DART AEROSPACE LTD	Work Order:	83095
Description: Crosstube Assembly (205/212 High Aft)	Part Number:	D212-664-241
Inspection Dwg: D212-664-241 Rev: D		Page 1 of 1

DRAWING NO.	TITLE	REV. D	DART AEROSPACE LT	D.E.O. NO.	SHEET NO.	SCALE
D212-664-241	CROSSTUBE ASSY (205	(212 HI AFT)	ENGINEERING ORDER	D212-664-241-D-1	SHEET 1 OF,2	NTS
DRAWN	CHECKED	(N	MFG. APPR.	APPROVED MP	DE APPR.	
DATE 11.04	.07 DATE	11.04.11	DATE /1.04.12	DATE 11/04/12	DATE 11-04.12

PURPOSE:

ADD AN INSPECTION WINDOW TO UNDERSIDE OF CROSSTUBE.

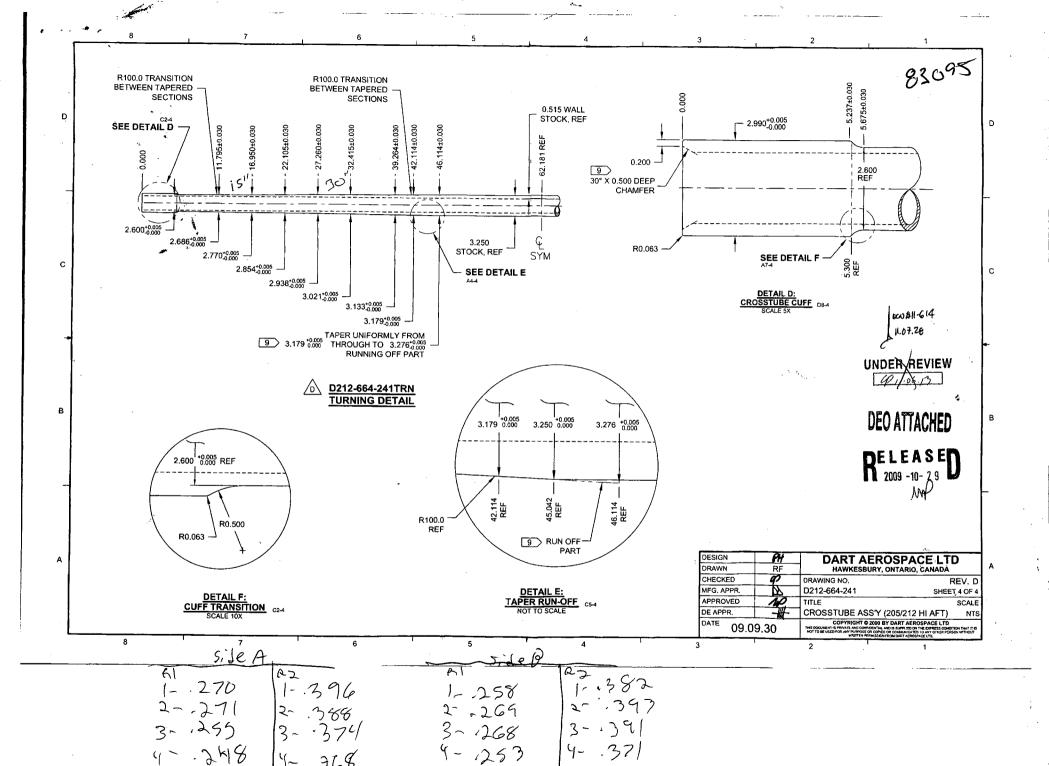
NOTES 2 OF SHEET 1 IS AMENDED AS FOLLOWS:

IS:

2) FINISH: CHEMICAL CONVERSION COAT PER DART QSI 005 4.1

PRIME INSIDE AND OUTSIDE PER DART QSI 005 4.2

MASK UNDERSIDE OF CROSSTUBE AS SHOWN (HATCHED AREA) AND

PAINT OUTSIDE PER DART QSI 005 4.2

REMOVE MASKING AND APPLY CLEAR COAT

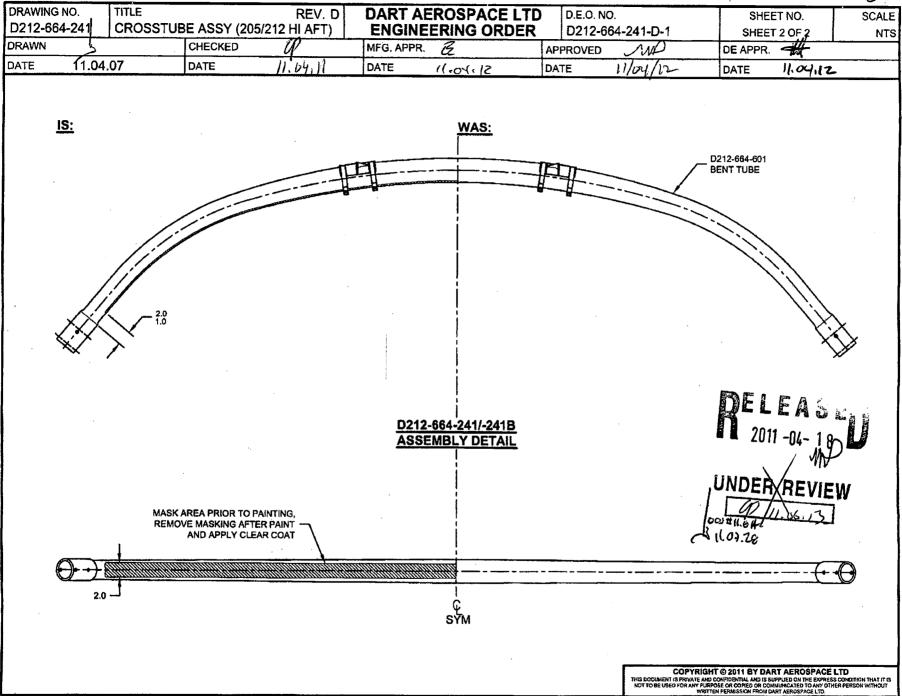
PURPOSE:

REPLACE MAGNOBOND WITH PROSEAL.

NOTE 12 & 15, SHEET 1 IS AMENDED AS FOLLOWS:

item	Qty -241	Qty -241B	Part Number	Description
7	A/R	A/R	PROSEAL 890 B-2	SEALANT, AMS-S-8802 CLASS B-2

- 12) TO INSTALL D2940-1 SUPPORT: ABRADE MATING SURFACE OF SUPPORT AND CROSSTUBE WITH 180-GRIT SANDPAPER AND REMOVE RESIDUE WITH MEK (OR EQUIVALENT). APPLY A 0.04" TO 0.07" THICK LAYER OF PROSEAL 890 CLASS B-2 (OR AMS-S-8802 CLASS B-2) SEALANT TO MATING SURFACE OF SUPPORT.
- 15) TORQUE CLAMPS 80 TO 100 IN-LB. ENSURE AT LEAST 1.5 THREADS SHOWING IN SAFETY AND THAT NUT HAS NOT BOTTOMED-OUT AFTER TORQUING. PRIOR TO PACKAGING, RE-CHECK TORQUE ON CLAMPS AFTER PROSEAL 890 SEALANT HAS CURED FOR 72 HOURS.
